**UNITED STATES  
NUCLEAR REGULATORY COMMISSION  
ATOMIC SAFETY AND LICENSING BOARD**

**REPORT OF  
DR. STEPHEN C. SHEPPARD, PH.D.  
IN SUPPORT OF  
CONTENTION NYS-16/16A/16B (“NYS-16B”)**

**Prepared for the State of New York  
Office of the Attorney General**

# Population Estimates for Evaluation of Severe Accident Mitigation Alternatives

**Figure 1: Region within 50 miles of IPEC**

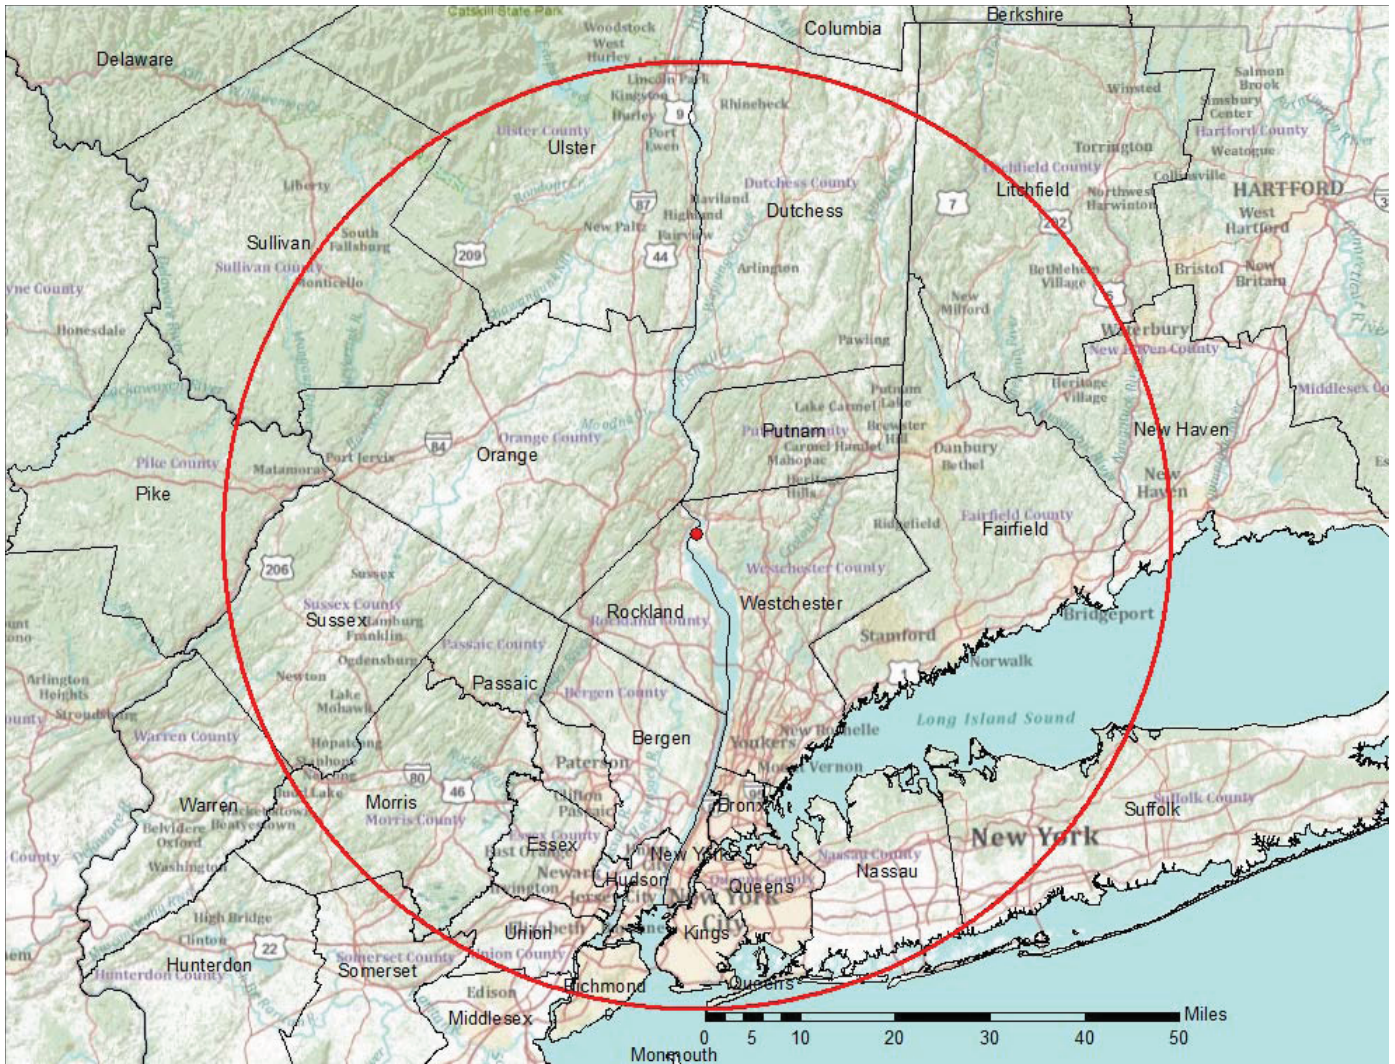
1. Determine those counties that are, in whole or part, within 50 miles of IPEC. This is illustrated in figure 1 below, where the red dot indicates the location of IPEC, the red ring indicates a distance of 50 miles from the plant, and county boundaries are outlined in black.
2. For those counties that are not entirely within the 50 mile radius, determine the percentage of land area within the county that is within the 50 mile radius.
